## ENGINEERING DATA TRANSMITTAL

# SNF Fuel Retrieval Sub Project Safety Analysis Document

EDT/ECN: 624281      UC: 510  
Org Code: 2T600      Charge Code: LD184  
B&R Code: EW7040000      Total Pages: 316

Figure 2-14. Multi-Canister Overpack Basket Stiffback Grapple.

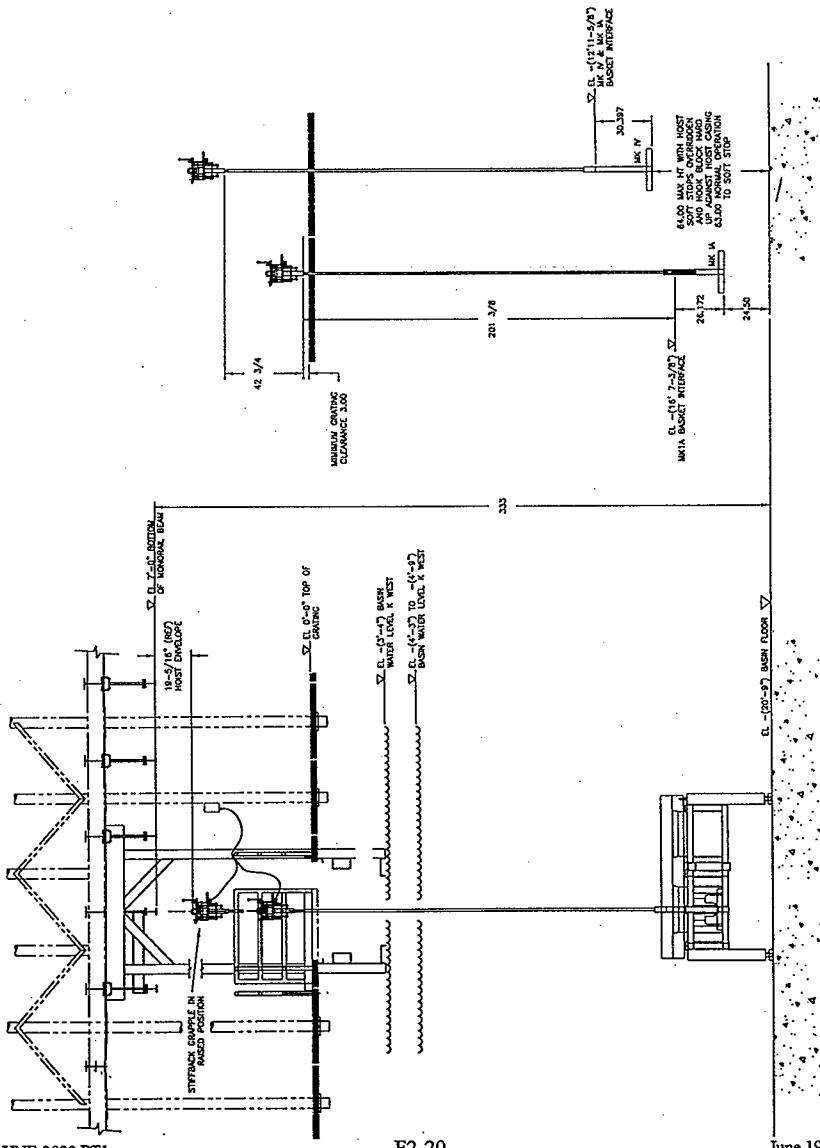
41	Figure 2-14: Print is inadequate. Provide better print or additional print with clear details. Engineering print w/parts listing is needed at a minimum. (2)	Y	The upgraded K Basin SAR will provide appropriate figures, it is inappropriate to provide engineering prints with detailed parts lists in the SAR.	CA
42	Figure 2-16: Print is inadequate. Provide better print with clear details. Engineering print w/parts listing is needed at a minimum. (3)	Y	The upgraded K Basin SAR will provide appropriate figures, it is inappropriate to provide engineering prints with detailed parts lists in the SAR.	CA
<b>Chapter 3, "Hazard and Accident Analyses":</b>				
	<i>General Comments:</i>			
43	How the hazards roll into this accidents is unclear. i.e. Not clear that the hazards are bounded by the accidents. Part of the problem is that the hazards' risks (real, X consequence) were not calculated. Also, did not provide freq for the "what if" HA, so risks cannot be calculated for those hazards, anyway.) Provide clear connection (framing) between the hazards and the accidents. Must show that all hazards other than standard industrial hazards are picked up by the accident list. (3)	Y	As part of the development of the upgraded FSAR, a hazards baseline will be prepared to cover all K Basin activities and update the existing hazards information.	CA

58	Page 3-28: 1st paragraph: State what this maximum lift height is. (3)	Y	The maximum lift height is shown on Figure 2-14.	CA
59	Page 3-29: Section 3.4.2.4.5; Section 3.4.2.4.5.5: The summary of safety structures and components in section 3.4.2.5.5 is not complete, or is inconsistent with Table 6-5 which lists the MCO basket-go/no-go gates and the process table. Also the stiffback grapple listed in section 3.4.2.5.5 is not shown on Table 6-3. (3)	Y	The MCO basket go/no-go gauge will be added to the process table bullet in section 3.4.2.5.5 and 3.4.2.6.5, and the stiffback grapple will be added to Table 6-5 when the K Basin SAR is upgrade for fuel removal operations	CA
60	Page 3-29: Section 3.4.2.5.5; 2nd paragraph: Didn't see the limit on moving leaded MCO baskets in the CSER. This limit is not mentioned in Chapter 6. (3)	Y	Limit 12 of Section 6 addresses limits on moving leaded MCO baskets.	CA
